**DA2024/219**

**39 BRYNAFON ROAD, DROMEDARY**

**CHANGE OF USE (TEMPORARY DWELLING TO SECONDARY DWELLING)**

**RE: PLANNING PERMIT (DA2024/219) 39 BRYNAFON ROAD, DROMEDARY.**

sheet  
**SITEPLAN**

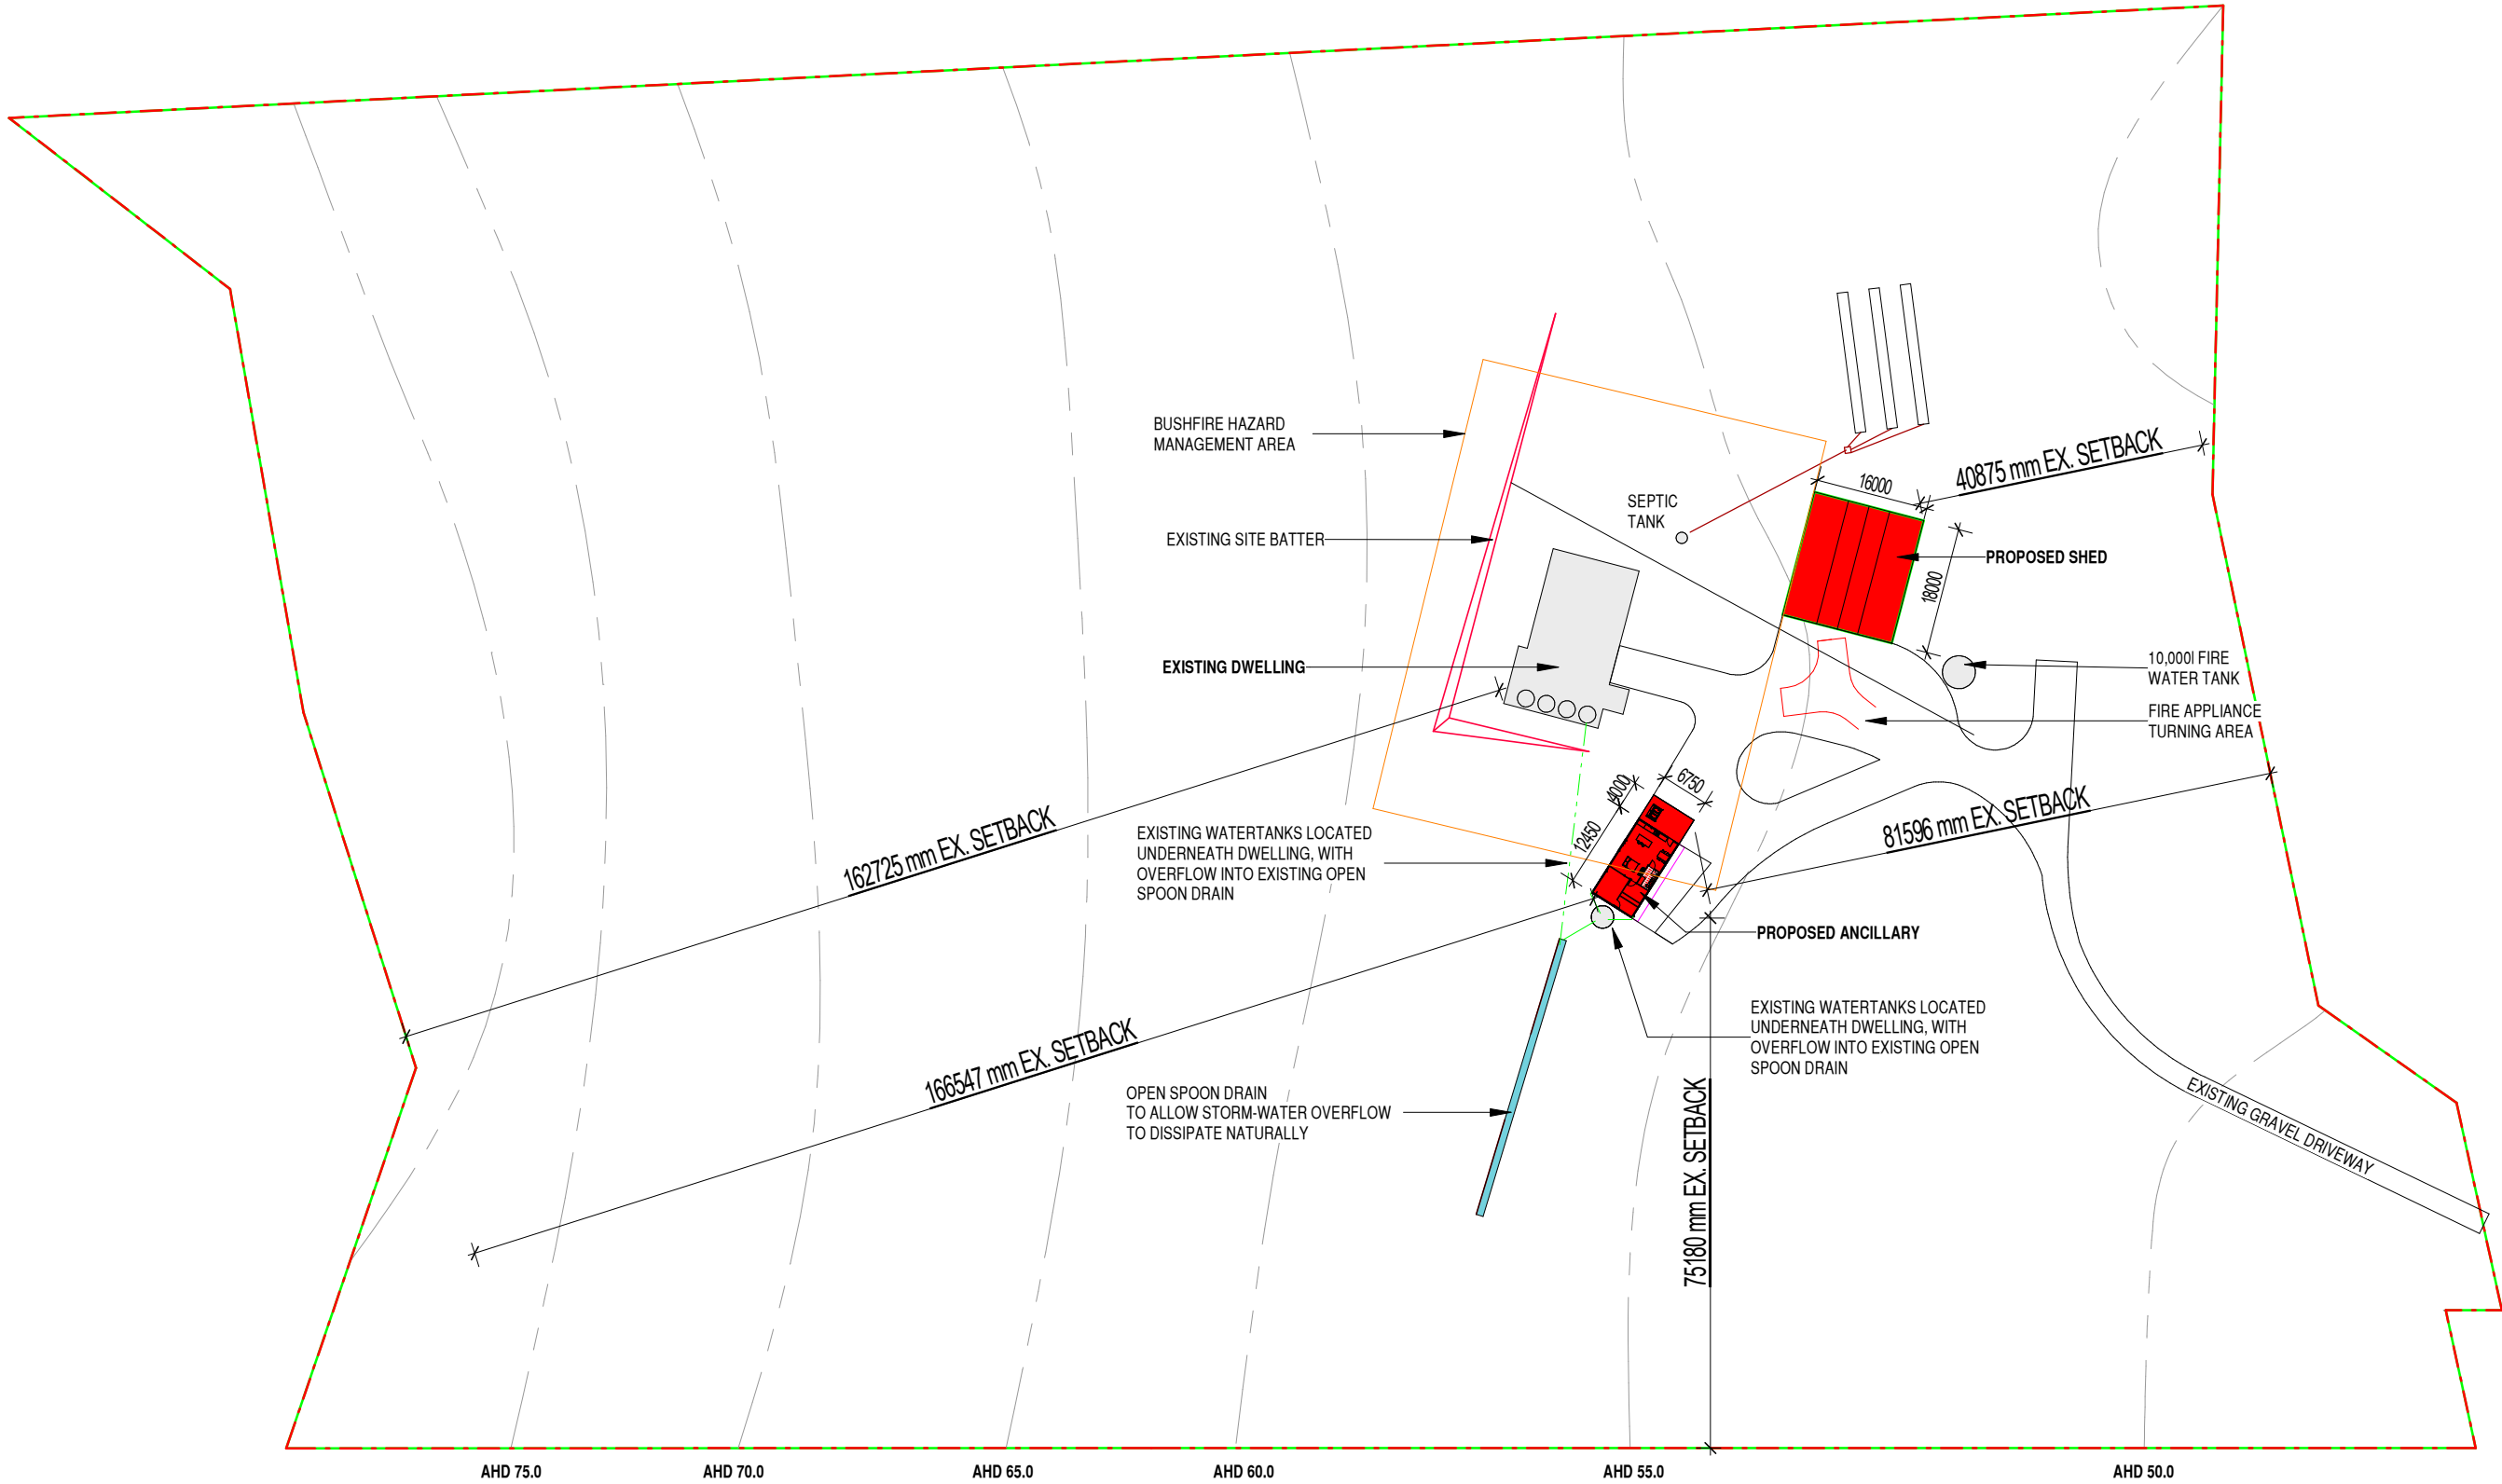
**Please provide an amended site plan that clearly identifies the site coverage of each building on the property. In addition, submit detailed floor plans for both the proposed secondary dwelling and the southern outbuilding, including clear identification of any additional or extended sections.**

***Reason: It has been identified that both the proposed secondary dwelling and the southern outbuilding have been extended without approval. As a result, the total site coverage on the property now exceeds 400sqm, triggering the need for assessment under Clause 11.4.1 P1 of the Rural Living Zone.***

*RHA RESPONSE: we have amended the areas on drawing DA-01, and shown the southern outbuilding as proposed (inc. dimensions on drawing DA-02. I have also attached the manufacturers drawings for the shed.*

sheet  
**FLOOR & ROOF PLAN**

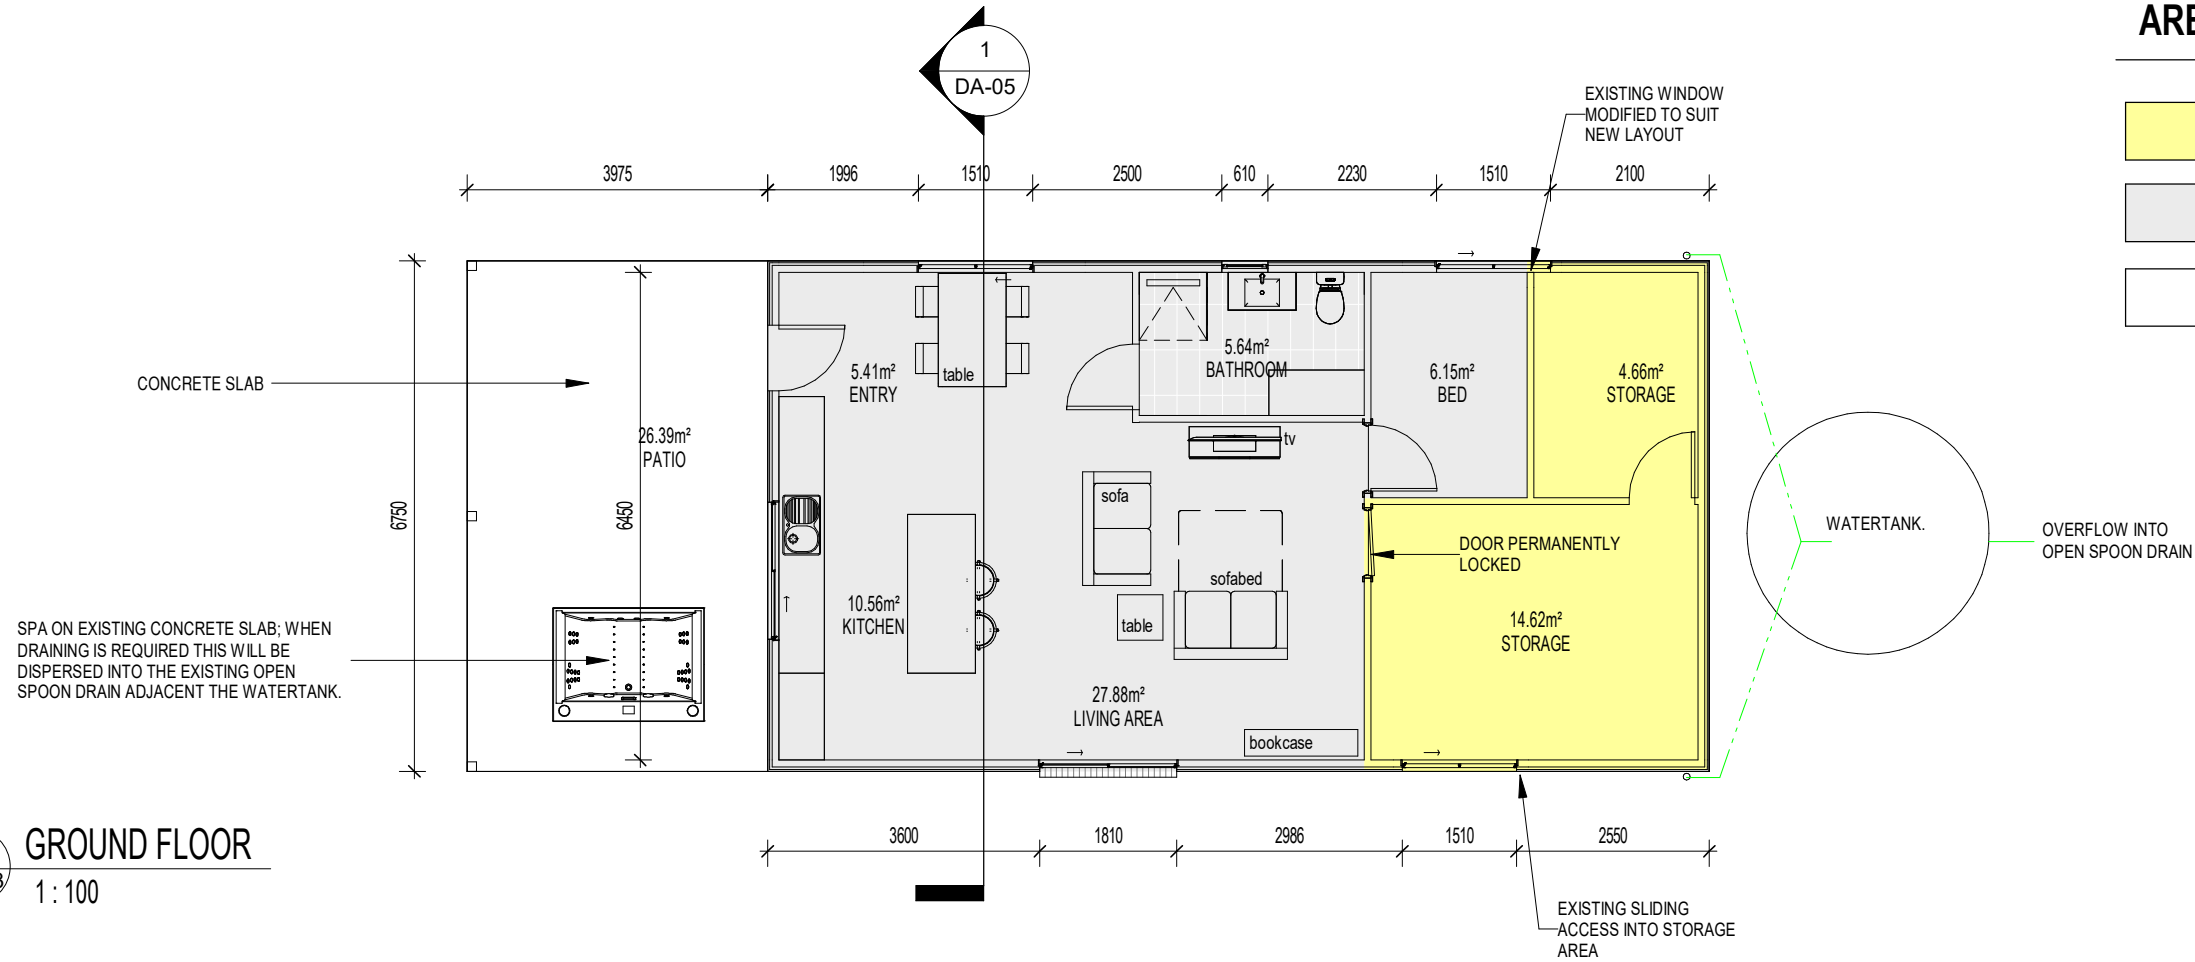
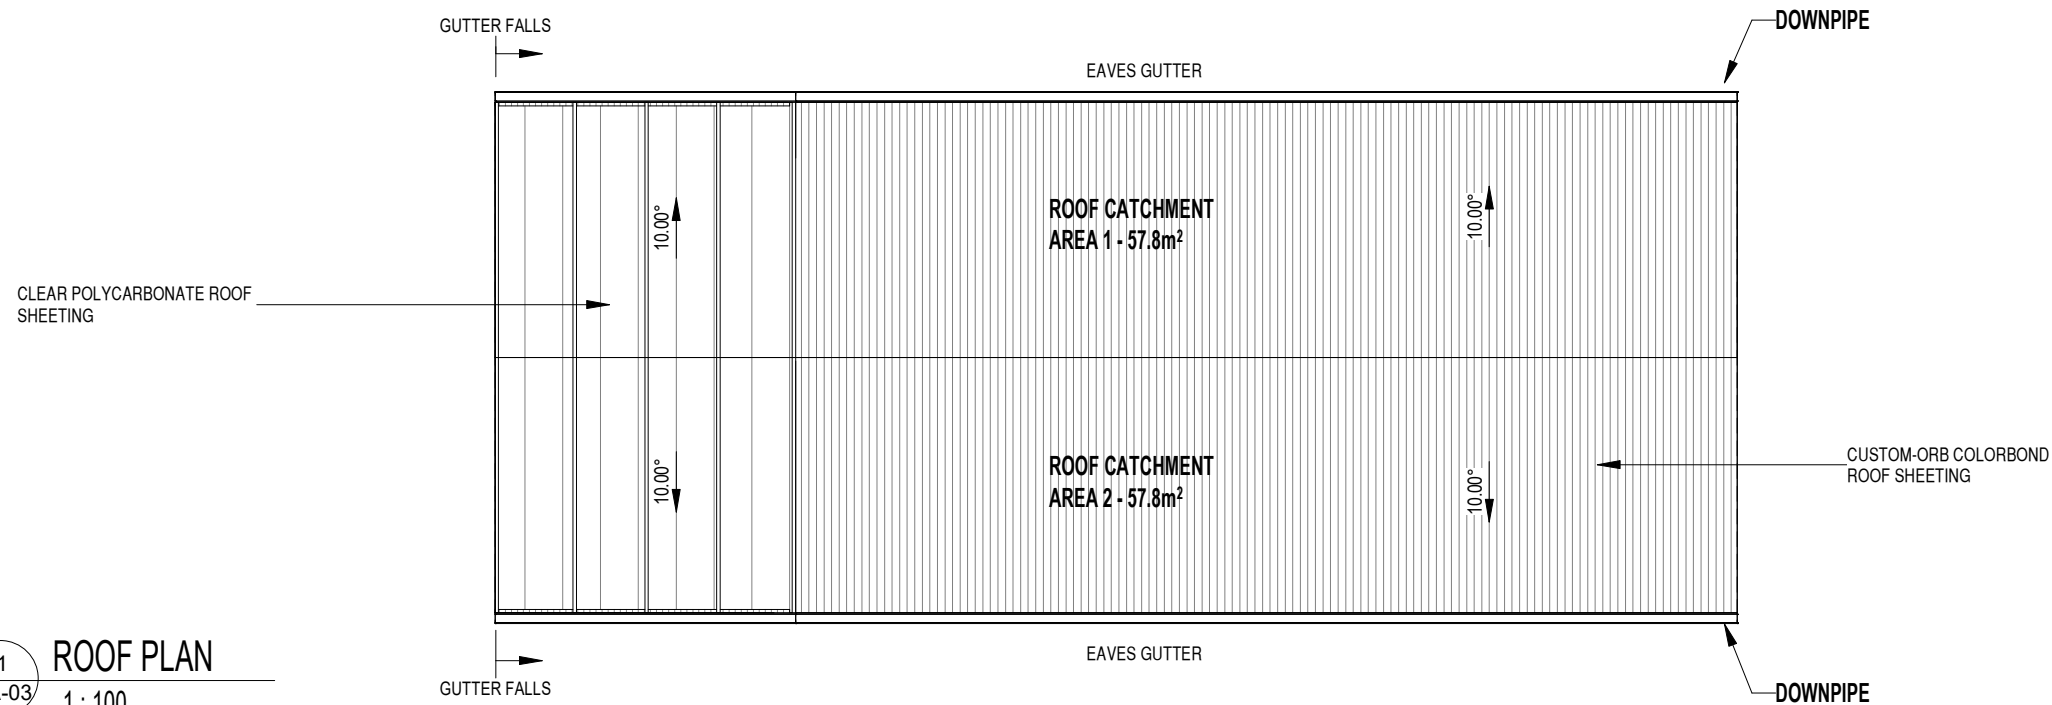
**Please provide an amended floor plan to confirm that the proposed secondary dwelling will have a gross floor area of less than 60sqm.**

***Advice: The current plan dated 5 December 2024 shows three storage areas that are accessible from within the proposed secondary dwelling. To address this, please consider modifying the rooms labelled "storage" by enclosing the wall facing the living area and creating an external access point. This would isolate the storerooms and reduce the floor level attributable to the secondary dwelling.***

*RHA RESPONSE: we have amended the floorplan to allow for the maximum 60m2 of ancillary space, and amended the room area to suit. Access is shown externally and the remaining internal door will be permanently fixed shut.*
